Request for Additional Information No. 5895 Revision 0

Next Generation Nuclear Plant Pre-Application Activities  
Department of Energy - Idaho National Laboratory  
Docket No. PROJ 0748

SRP Section: ARP FQ/MST - Fuel Design Qualification/Mechanistic Source Terms  
Application Section: Fuel Qualification and Mechanistic Source Terms

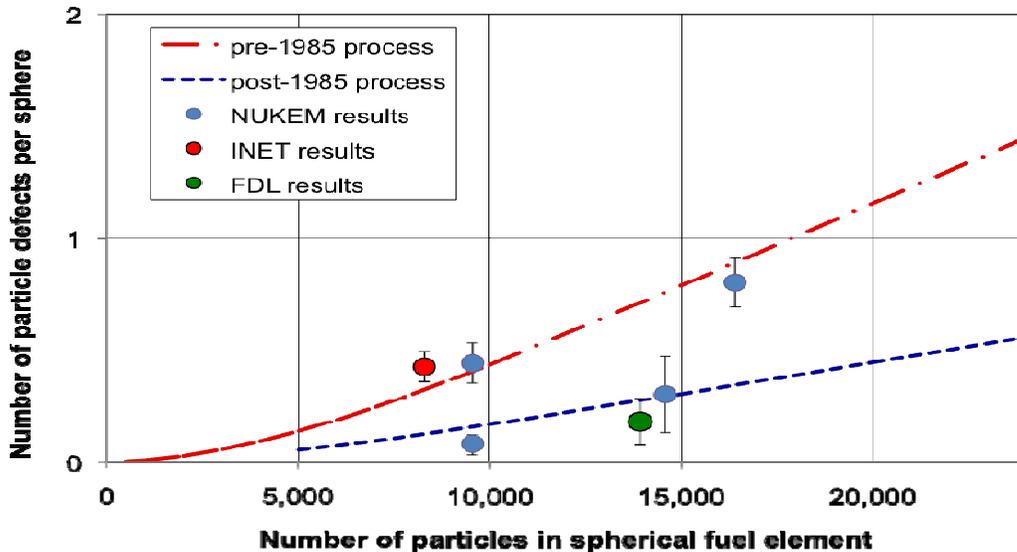
**RAI FQ-B56 / MST-B56:** Provide the pre-irradiation as-fabricated quality data on recent UO<sub>2</sub> TRISO fuel particles fabricated into: a) spherical fuel elements in South Africa's FDL (described on page 80); and b) fuel compacts at ORNL for inclusion into the AGR-2 irradiation test (described on page 89) now underway at the ATR in Idaho. Discuss the as-fabricated quality data relative to the NGNP pebble bed as-fabricated requirements (Table 16) and prior German fabrication experience (Tables 2 and 3). Inclusion of this data will provide important information regarding the status pebble bed fuel manufacturing capability today. (FQ Section 5.2.2.2, page 79) {MJK/F8} [1(b)-ii, 2-ii]

Comment: The FQ white paper provides no reference to as-manufactured quality data of UO<sub>2</sub> TRISO fuel particles fabricated in recent years in South Africa. These fuel particles have in at least two campaigns been fabricated into: a) spherical fuel elements in South Africa's FDL (described on page 80); and b) fuel compacts at ORNL for inclusion into the AGR-2 irradiation test, now underway. Both of these campaigns appear to be part of the approach outlined in FQ Sections 5.2.2.1 and 5.2.2.2 on pages 78 - 82.

At the HTR-2010 conference in Prague (October 2010), results were presented on "Recent Advances in HTR Fuel Manufacture" [Ref.]. The FQ white paper presents as-manufactured fuel quality results on HTR pebble bed fuel element fabrication based on the German experience from the 1980's, the HTR-10 fuel element production in China, and recent results from South Africa's FDL production of spherical elements (see figure below). The South African fuel fabrication work appears to be part of the effort (Testing of Laboratory-Produced Fuel Spheres) described on page 80 of the FQ white paper.

This important information should be included in the FQ white paper together with detailed discussions as to how well the pre-characterization data meet NGNP as-fabricated quality requirements (page 62, Section 4.2.3.1 and Table 16, page 72) and fuel element characteristics (listed on pages 76 and 77). Comparisons to previous German production campaigns should also be provided. Failure to include these data impedes understanding of the current production capability for UO<sub>2</sub> TRISO fuel and spherical fuel elements for the NGNP pebble bed concept.

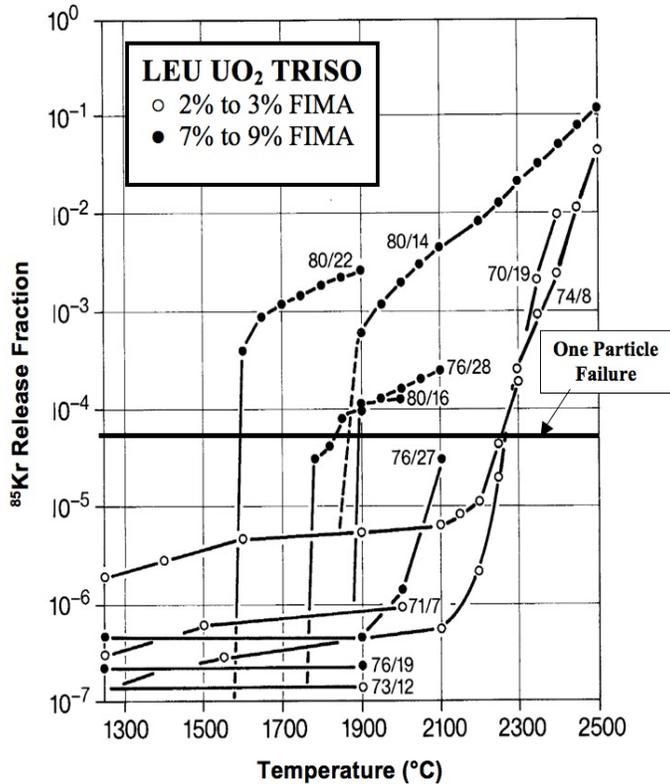
**RAI FQ-B66 / MST-B66:** In discussing NRC requirements for fuel and fuel qualification, it would be useful to describe the basis for each of the fuel-related General Design Criteria and address the applicability of those GDCs to the NGNP. If a particular GDC is not directly applicable to the NGNP design, then identify analogous criteria for the NGNP and state how those criteria will be satisfied. (Section 2) {MJK/S2}

Reference: W. Schenk, G. Pott and H. Nabelek, J. Nucl. Mat. 171 (1990) pp. 19-30

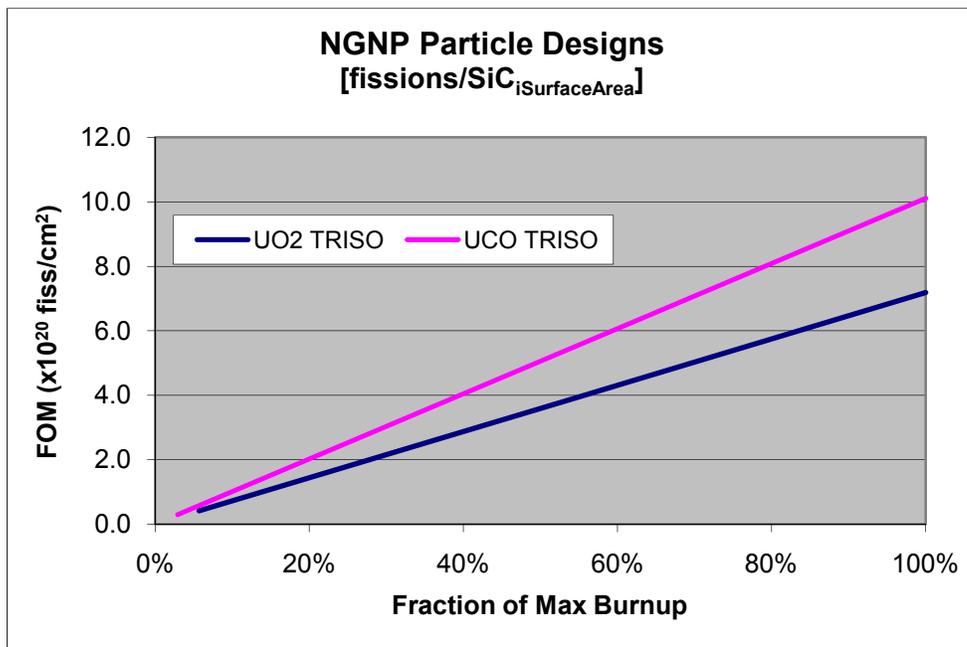
**RAI FQ-B79 / MST-B79:** Please clarify how the FQ Table 16 requirement for  $^{110\text{m}}\text{Ag}$  release for NGNP fuels applies to accident conditions. Based on prior German isothermal heating test performed on an irradiated HFR-K3 sphere containing high-quality LEU  $\text{UO}_2$  TRISO particles, the  $^{110\text{m}}\text{Ag}$  release was  $>10^{-2}$  upon reaching the soak temperature of 1600 °C. [Ref.] This element was irradiation at operating temperatures in the range of 1000°C to 1200 °C to a burnup of 7.5% FIMA and a fluence of  $\sim 4 \times 10^{25}$  n/m<sup>2</sup> ( $E > 16\text{fJ}$ ). These conditions are significantly below those listed in Table 14 for the prismatic NGNP concept. (FQ Section 4.3.3, Table 16) {MJK/FS4.7}
